### PRE-APPLICATION CONFERENCE REPORT

#### Gee Creek Sanitary Sewer Facilities

File No. PLZ-25-0145

**Figure 1. Project location and site plan**

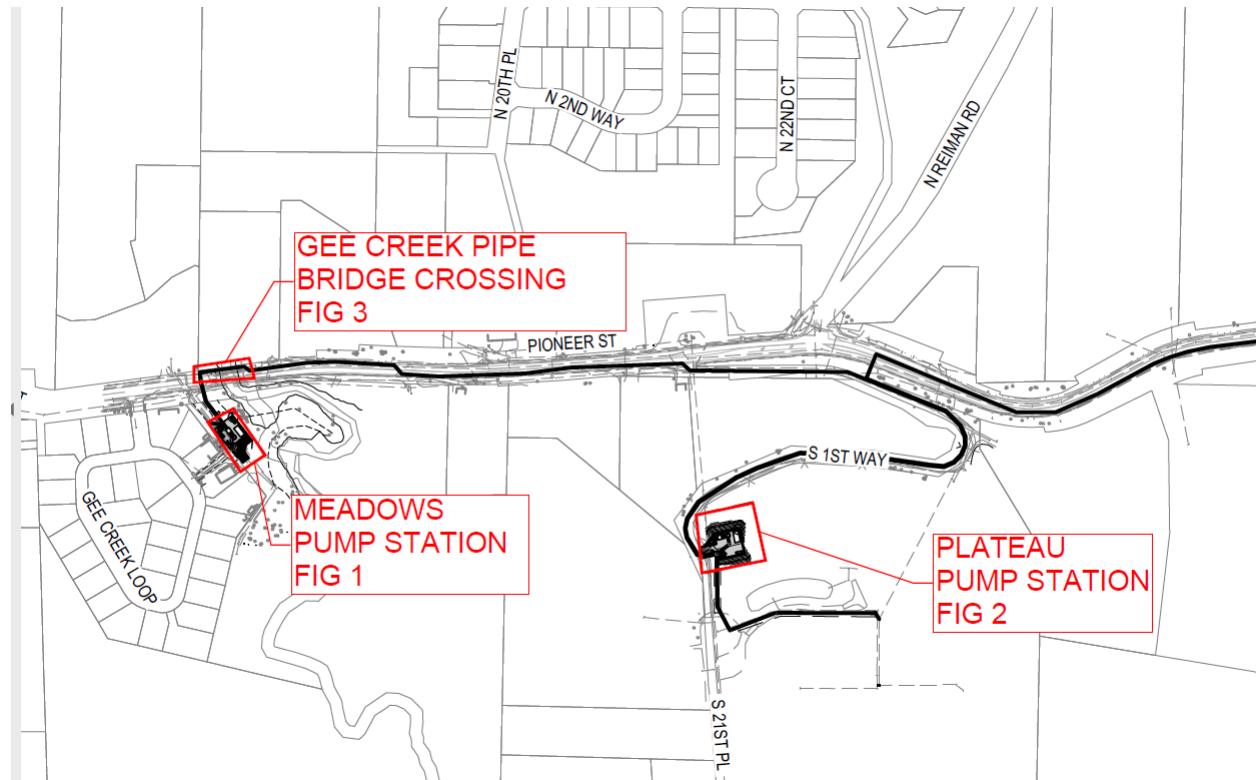
The Gee Creek Trail should wrap around the meadows Pump Station. Coordinate with City parks on trail options for pipe bridge
